Intake Diversion Dam

Fish Protection and Passage Concept Study Report II

Lower Yellowstone Project
Yellowstone River, Montana

Appendix C: Value Engineering Study Responses

FIGURE 13

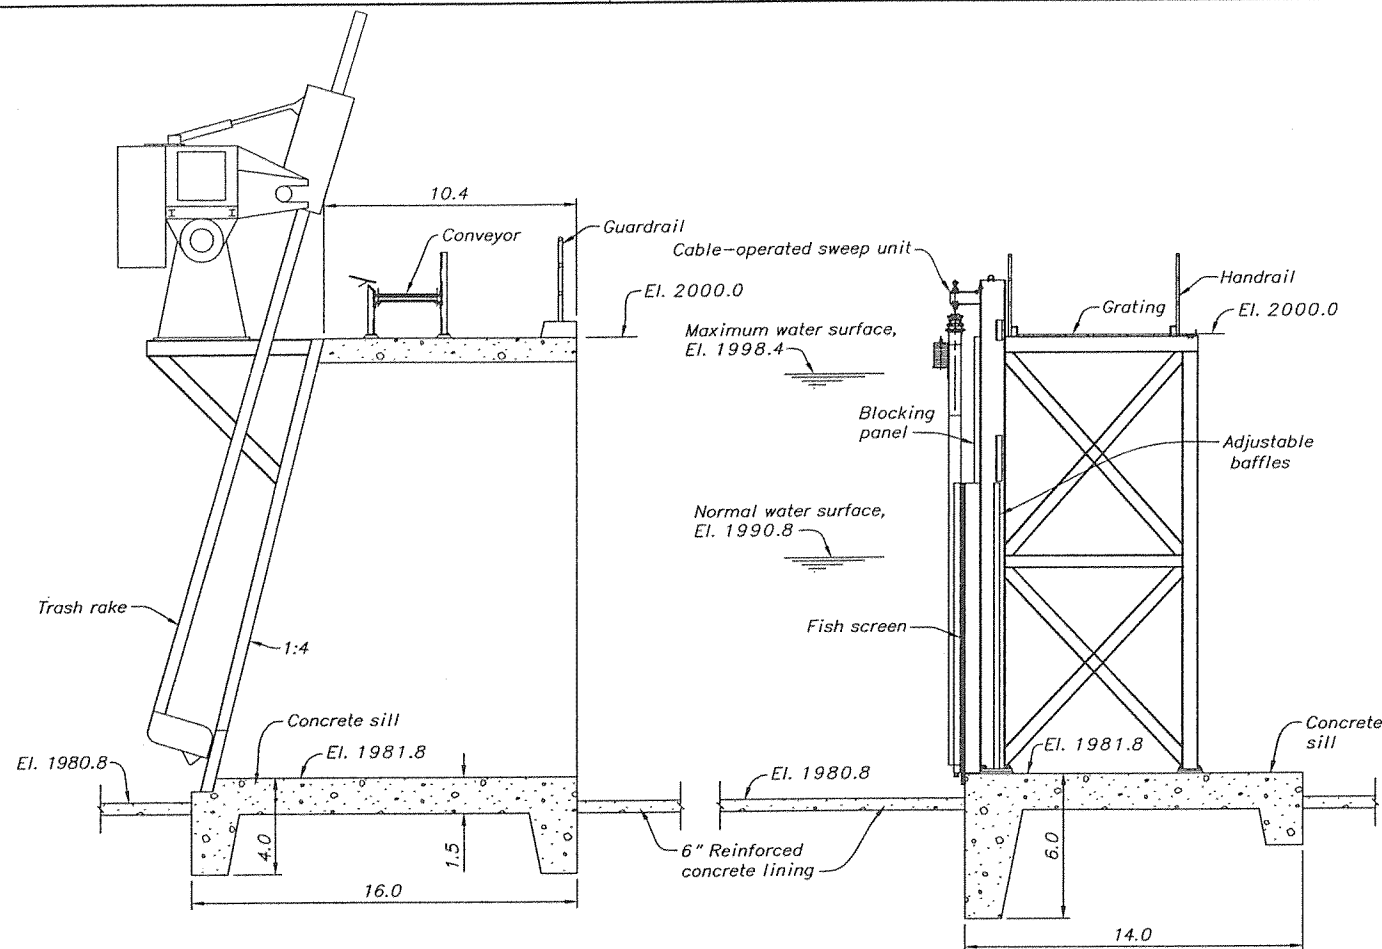
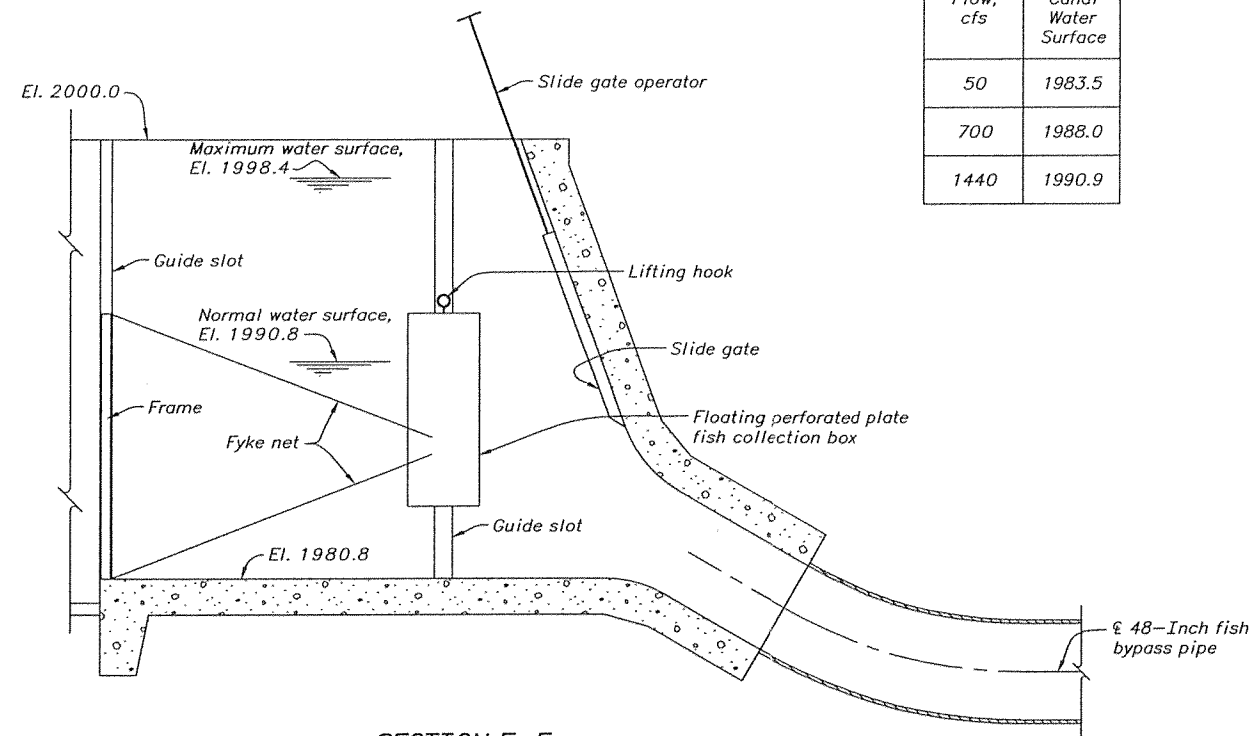
VE Proposal No. 8. – Replace baffles with perforated plates. The plates would be epoxy coated steel plates. Two perforated plates would be used behind each screen panel. One plate would be fixed while the other perforated plate would be on a screw movement system, which would allow the perforated plate to slide up or down, thus changing the porosity. Estimated savings are \$725,000.

Response. – This proposal is accepted. The perforated plate option is less expensive and allows easier adjustments.

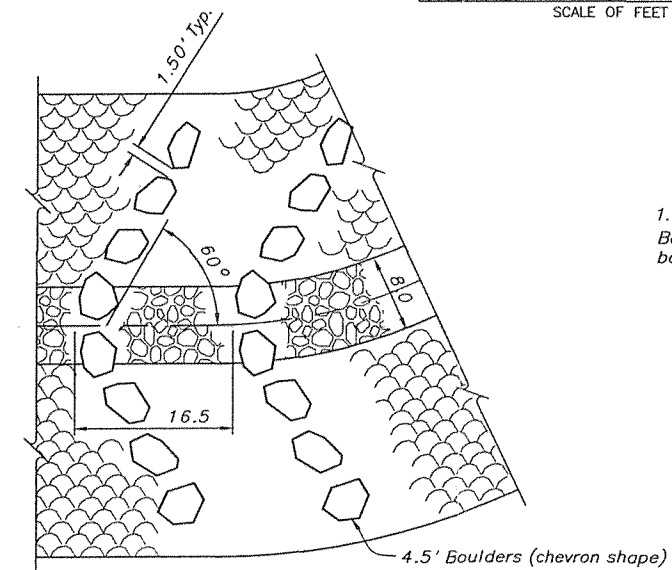
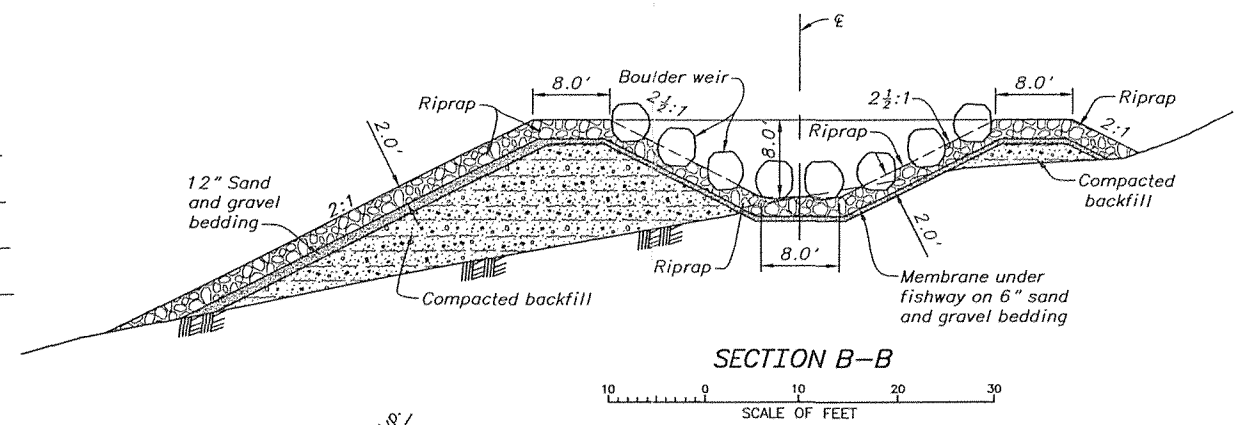
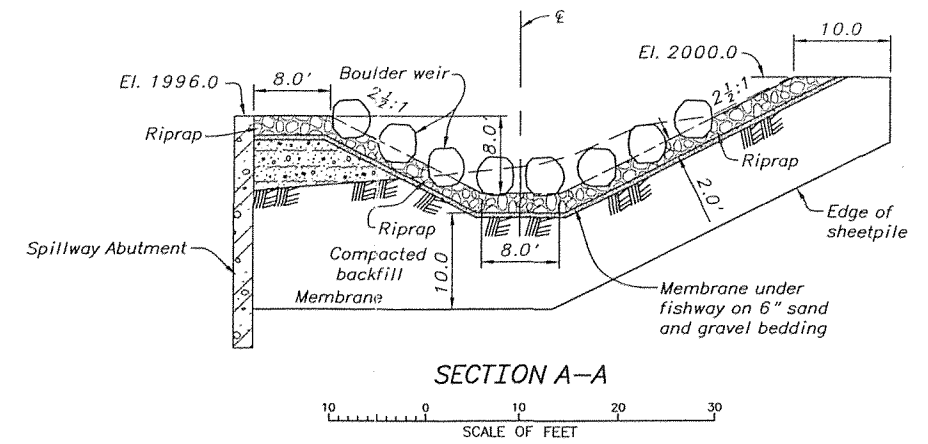
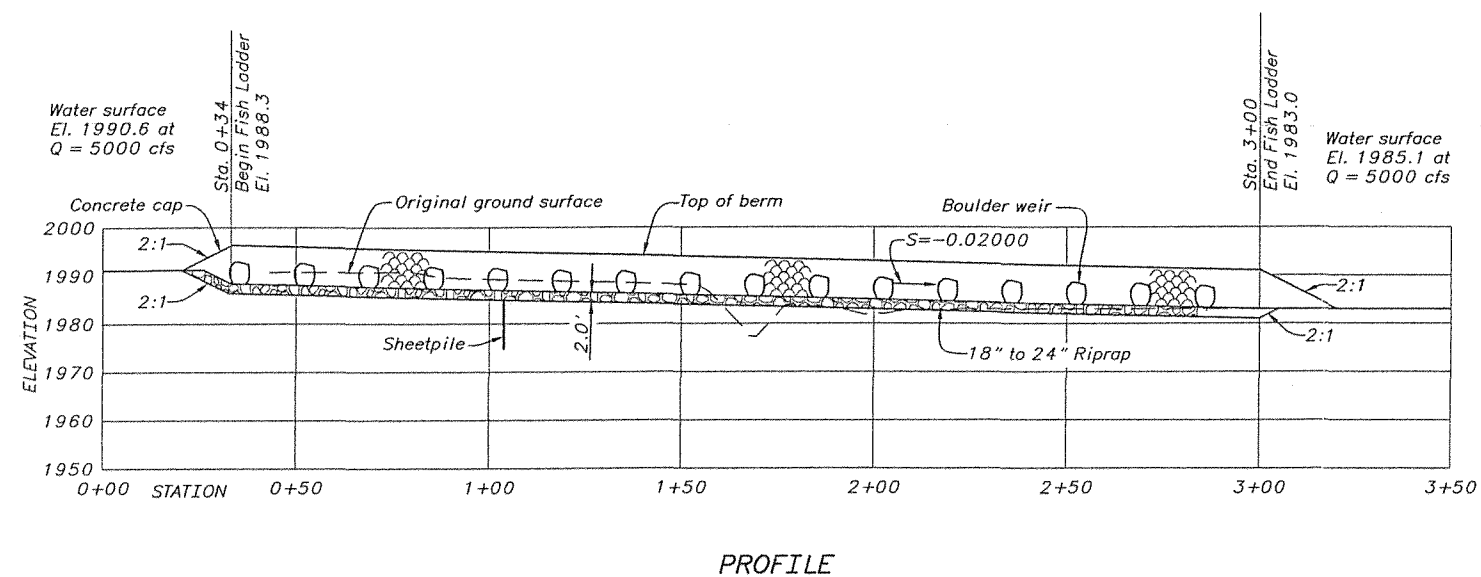
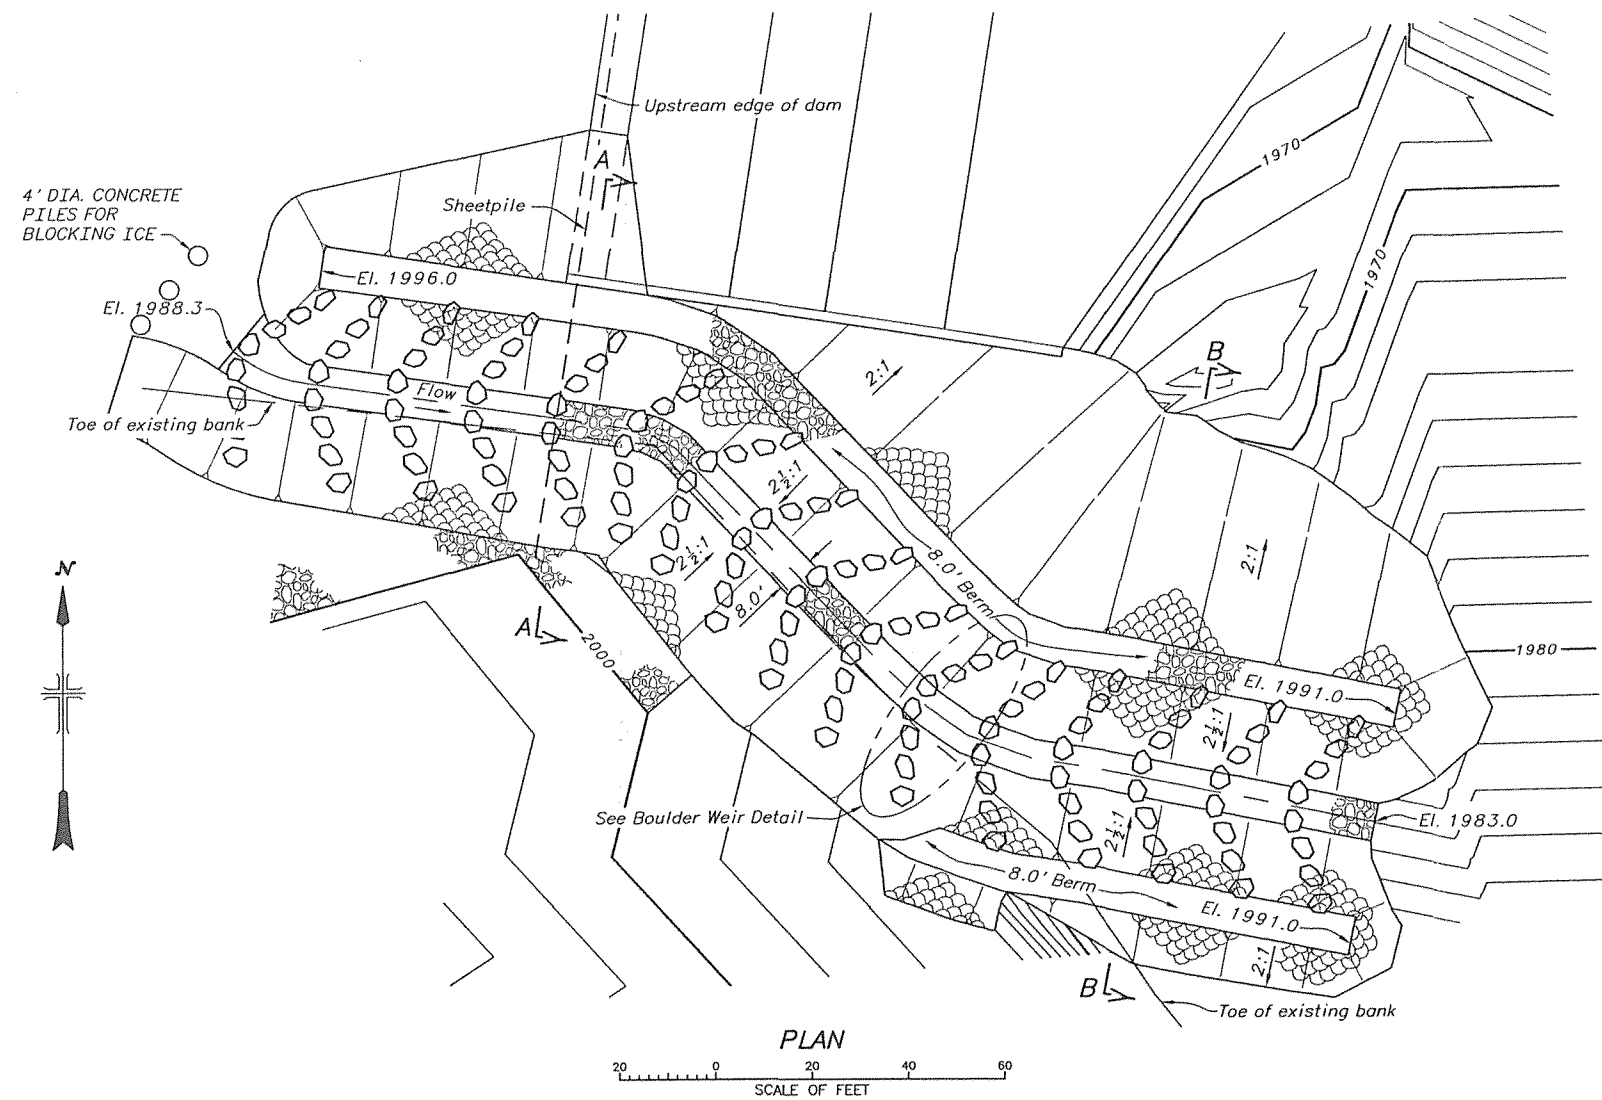
A concrete weir option for replacing the spillway has been added.

i
ii
iii
1 through 30 *
Figure 15 **
Concrete Weir Cost Estimate Sheet ***

* Revisions are on pages 2, 19, 20, and 26.

** Revised May 12, 2004.
